NSLPP MEETING HELD ON 01/02/2023

ADDRESS/WARD: 44 Ellalong Road, Cremorne

APPLICATION No: DA142/22

PROPOSAL: Alterations and additions to an existing dwelling house including a swimming pool and associated works

Figure 9: South-west elevation

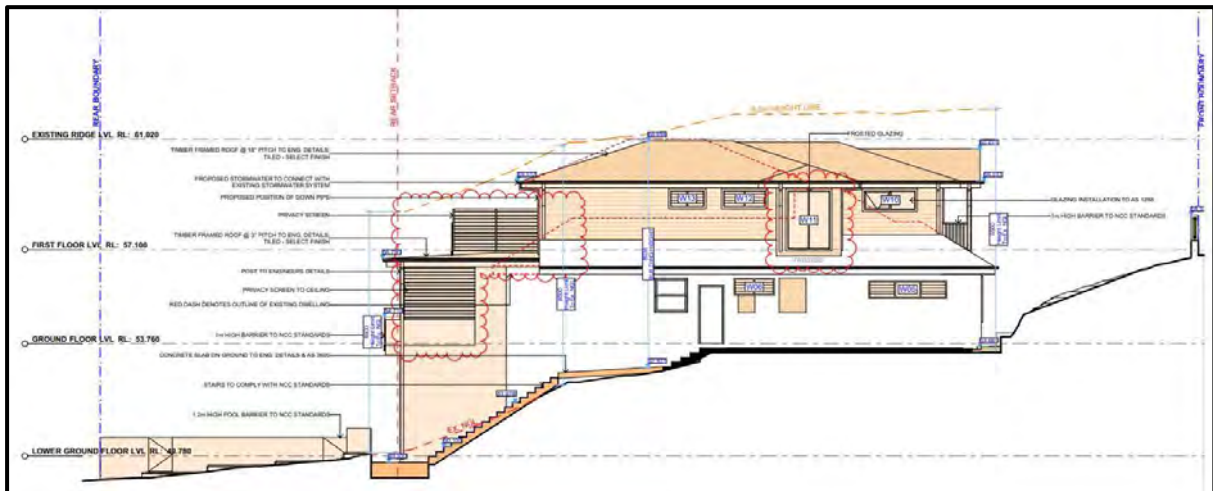
The revised design involves providing frosted glazing for the stairwell window (refer to window reference W11 – on south-west elevation) and privacy screens along the sides of the balconies (both ground floor and first floor). The amended proposal is not considered to have additional or greater impacts compared to the original design in terms of amenity, views or streetscape impacts. Therefore, re-notification was not required in accordance with Council's Community Participation Plan.

Response: The Assessment section above provides detailed discussion on the proposed development in terms of amenity and privacy impacts. The stairwell window has been modified to have frosted glazing.

Figure 27: Height plane diagram – aerial view

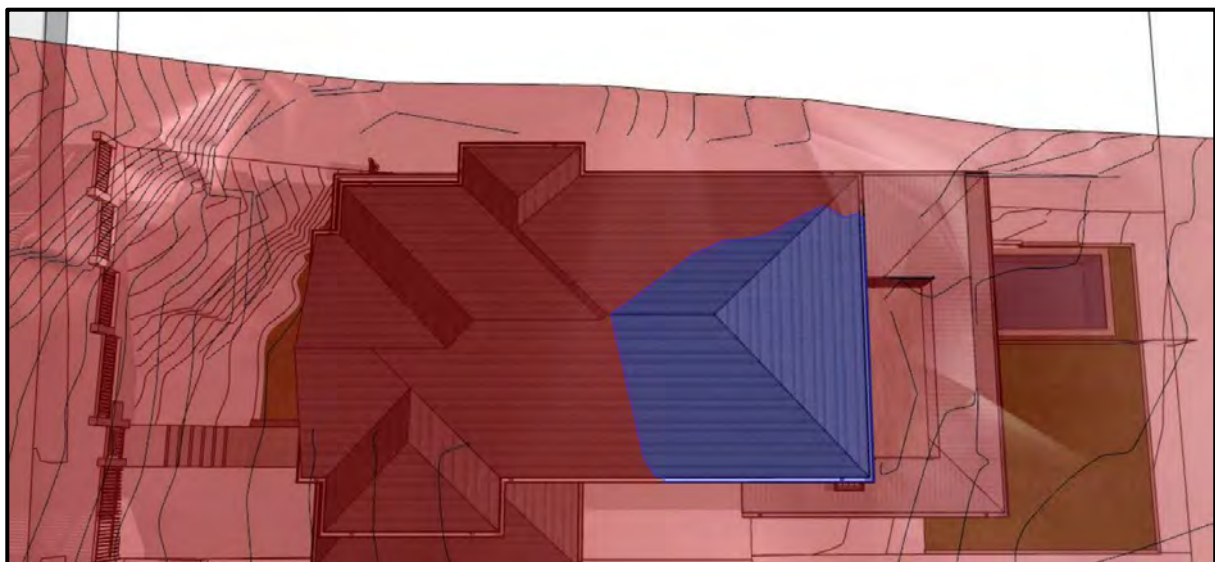
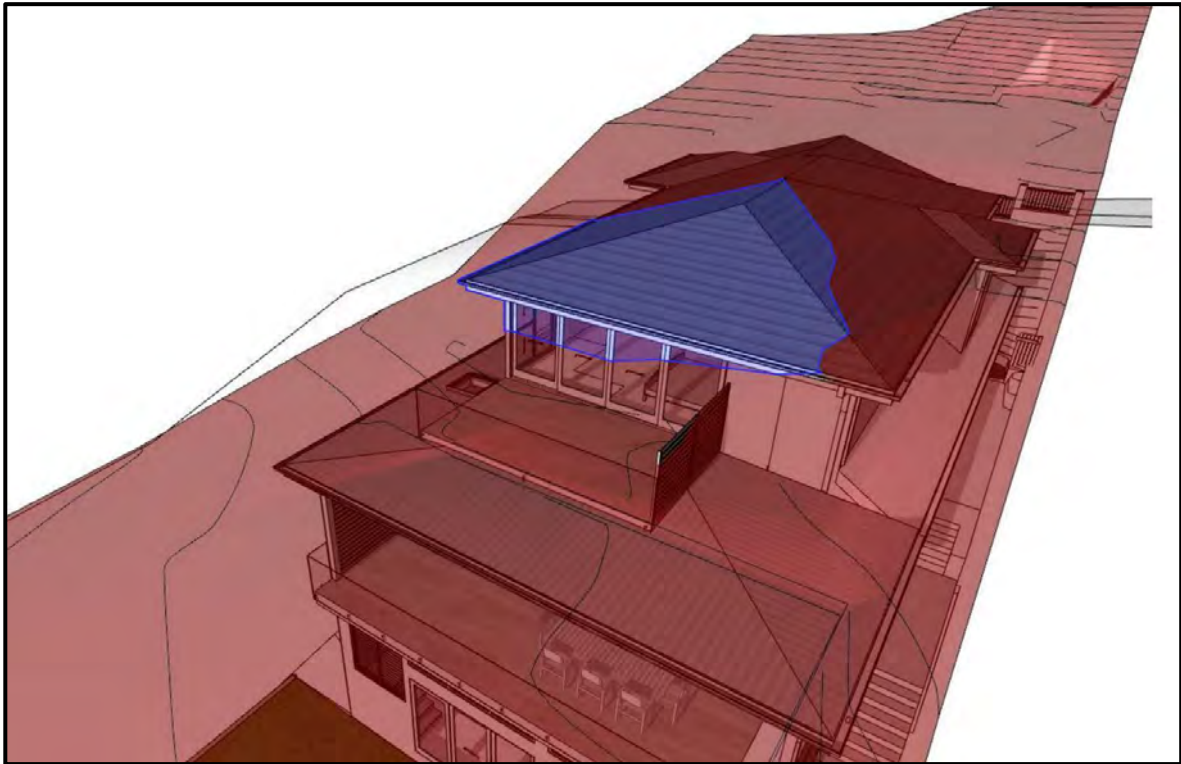
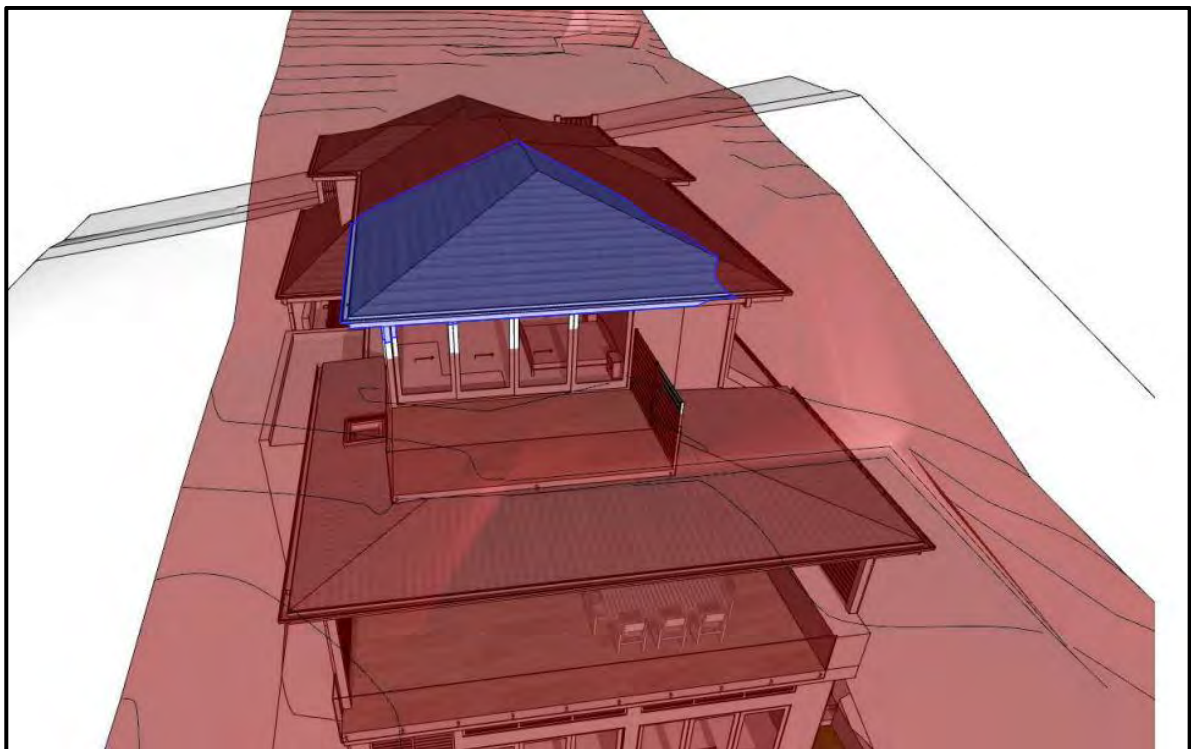
As described above, the proposed development involves a maximum height of 10.2m, which represents a 1.7m or 20% variation to the maximum height of buildings development standard.

The proposed development has been designed to conform to the landforms and with respect to the significant fall to the rear boundary and the dramatic change in levels, unique to the site. Despite the challenging topography, it is noted that the majority of the built form complies with the 8.5m height limit and the primary components that exceed this are associated with the back of the upper level roof, in a location where the site experiences a significant fall. The location and design of the non-compliant components are such that the height variations will not be highly visible nor impactful when viewed from public domain and can be regarded as minor. This objective is achieved by the proposed development.

Existing deck – ground floor

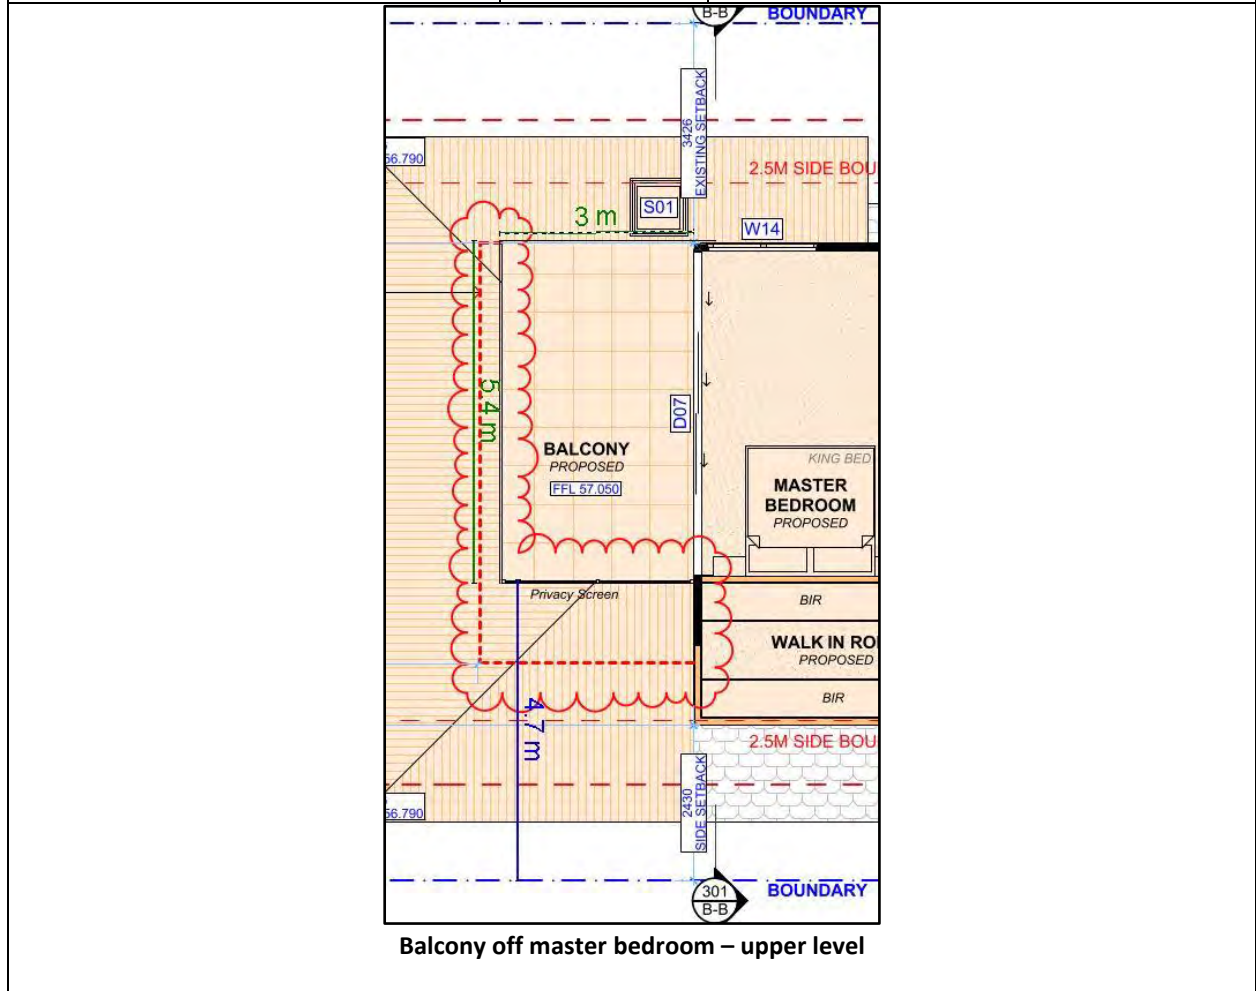
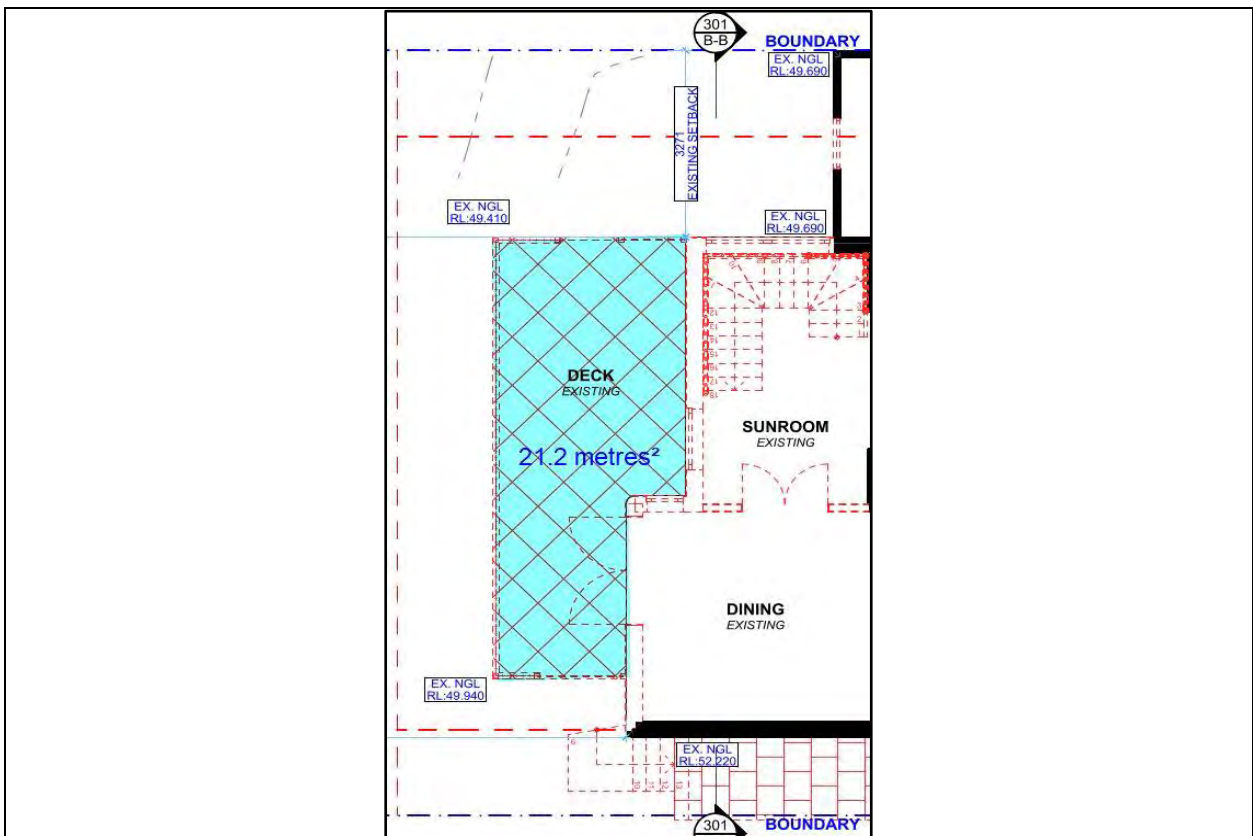
<p>Deck</p> <p>The proposed deck on the ground floor is an extension of the existing deck. This space will be increased in size from 21.2m² to 30.1m² in area, and will have reduced side setbacks compared to the existing deck. Notwithstanding this, the proposed deck does comply with the required setbacks and also features floor to ceiling privacy screens along both sides – ensuring any acoustic impacts are minimised. It is further noted that the deck is elevated due to the unique design of the dwelling house and ground floor, and the dramatic change in existing ground levels at this portion of the site. A number of elevated internal and external living and leisure spaces occur through the locality and the proposed deck (as per the existing deck) demonstrates merit and appropriately suits the site context and setting. On balance, any potential acoustic privacy impacts associated with the proposed deck are considered reasonable and acceptable.</p>

Compliance diagram – landscaped area (shaded in green) and un-built upon area (shaded in cyan)

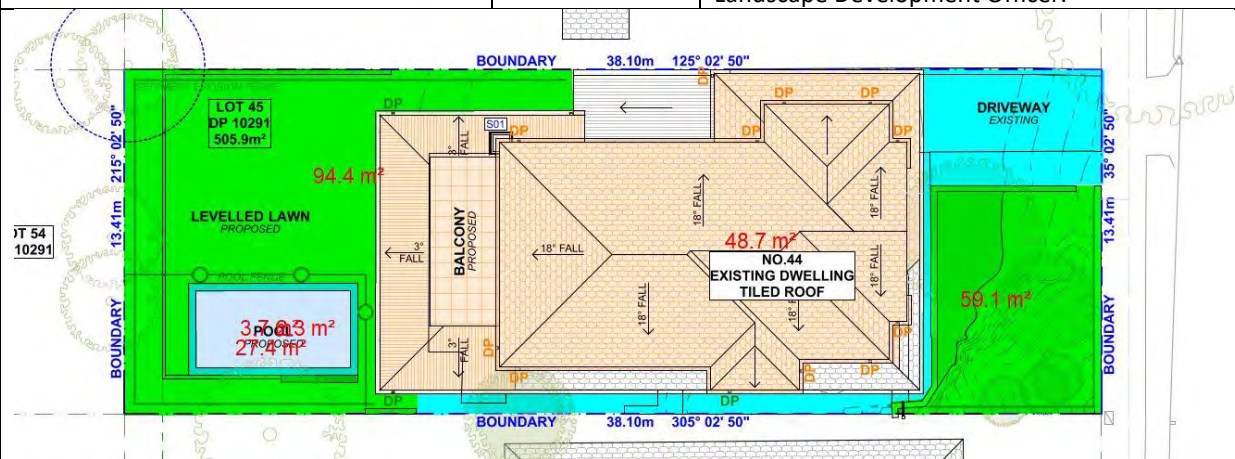
While these components provide significant improvements to the dwelling house in terms of residential amenity, functionality and facilities, these variations are of concern when considered in light of current controls against which this proposal must be assessed. The new pool will provide additional recreational spaces for future occupants to enjoy. A pool was approved previously (DA134/14) but that is not constructed and not relevant to this consideration.

The proposed carport and first floor bedroom addition toward the street however contribute to a reduction at the front of the site. To ensure the proposal is appropriately scaled at the front of the site, a condition is recommended to amend the proposal to delete the proposed car port and reduce the first floor bedrooms resulting in a reduction in site area coverage of approximately 30.7m² (6%). Whilst these amendments would still result in non-compliance, the variation would be more consistent with the built form and scale of adjoining dwellings. The resultant site coverage would be approximately 243.2 square metres or 48.1%

Site coverage remains of concern, and it is recommended that a condition be imposed reducing this by approximately 6% to 48%. It is open to the applicant to explore other alternatives to achieve this goal. However, that would require a modification to this consent.
